DEVELOPMENT ASSESSMENT REPORT

Application No.	DA/2023/0333
Address	140 Young Street ANNANDALE
Proposal	Part demolition and alterations and additions an existing dwelling house
Date of Lodgement	13 June 2023
Applicant	David Jarvis
Owner	Ms Rachel C Budd
Number of Submissions	Initial: 0
Value of works	\$491,600.00
Reason for determination at Planning Panel	Clause 4.6 variation exceeds 10% (Maximum allowed FSR)
Main Issues	Departure from Floor Space Ratio development standard Departure from Site Coverage development standard
Recommendation	Approved with Conditions
Attachment A	Recommended conditions of consent
Attachment B	Plans of proposed development
Attachment C	Section 4.6 Exception to Development Standards
Attachment D	Statement of Heritage Significance

This report is an assessment of the application submitted to Council for part demolition and alterations and additions an existing dwelling house at 140 Young Street Annandale.

Figure C128: Building Location Zone

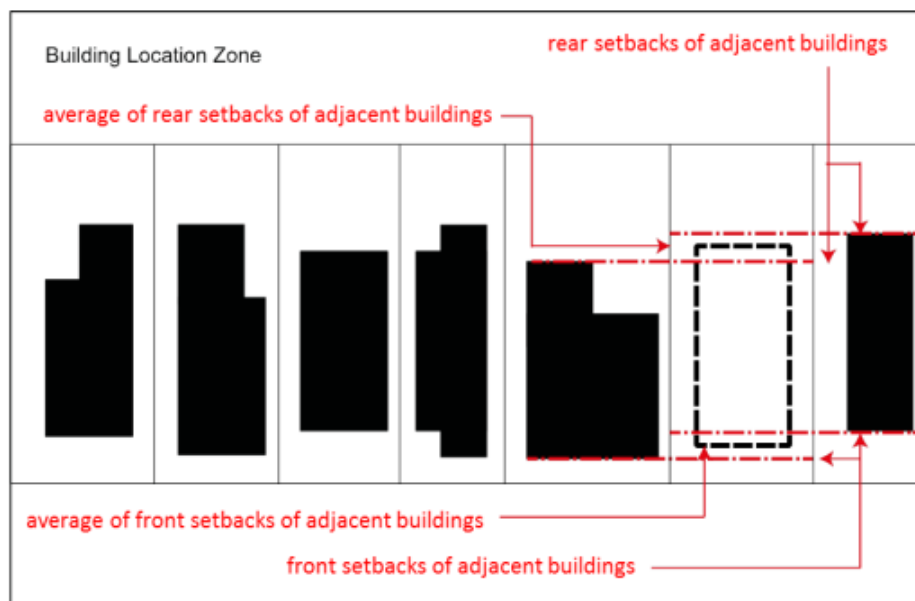
To calculate the average rear first floor setback of the subject site, the average rear setbacks of the immediate adjoining dwellings are used as per Figure C128: Building Location Zone shown below.

Pursuant to C6 of this part of the LDCP 2013, to gain support for the proposed rear first floor additions and its BLZ proposed, various requirements need to be demonstrated to be met. An assessment of the proposal against these tests is carried and is considered acceptable for the following reasons:

Fig 1 – GFA/FSR calculations are provided in the diagram above.

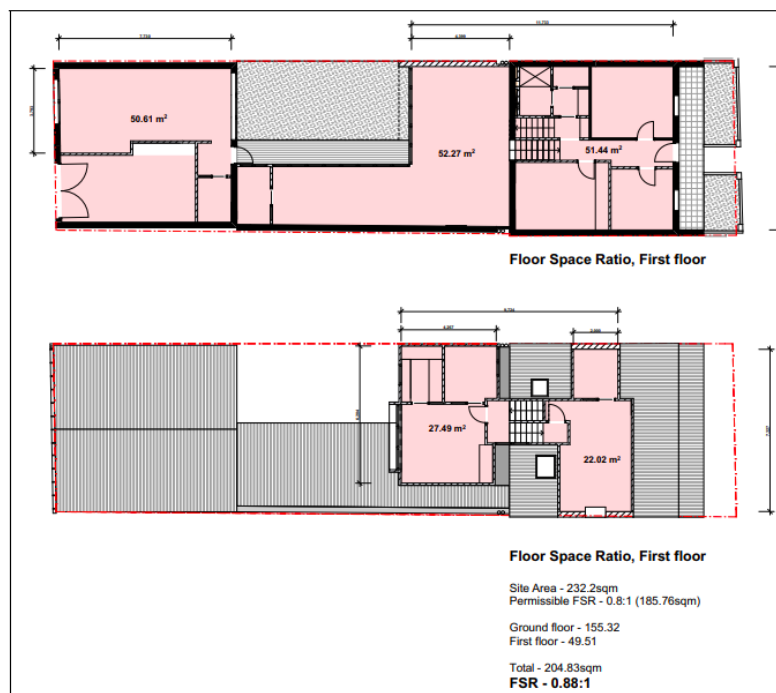
The Aim of the request: To allow the site to provide a FSR of 0.88:1.

Fig 1 – Site coverage calculations are provided in the diagram above, noting that the site coverage of 76.9% is maintained on the site.

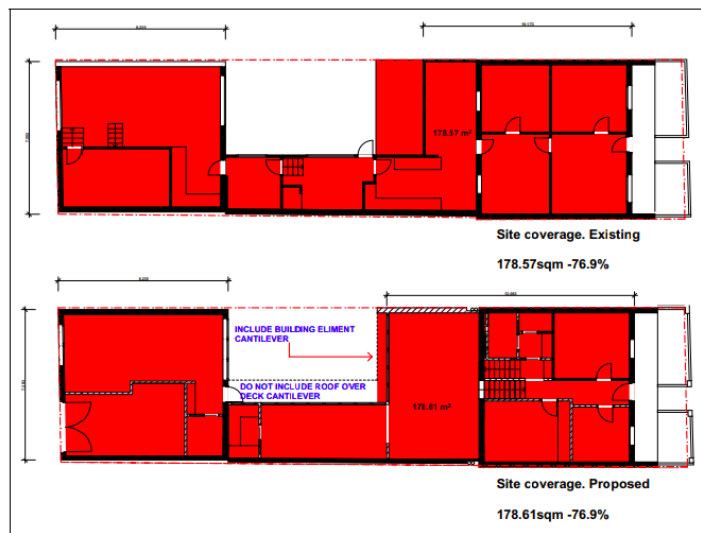
The Aim of the request: To allow the site coverage area of 178.6m² or 76.9% to be provided (retained). The landscaped area is complied with.
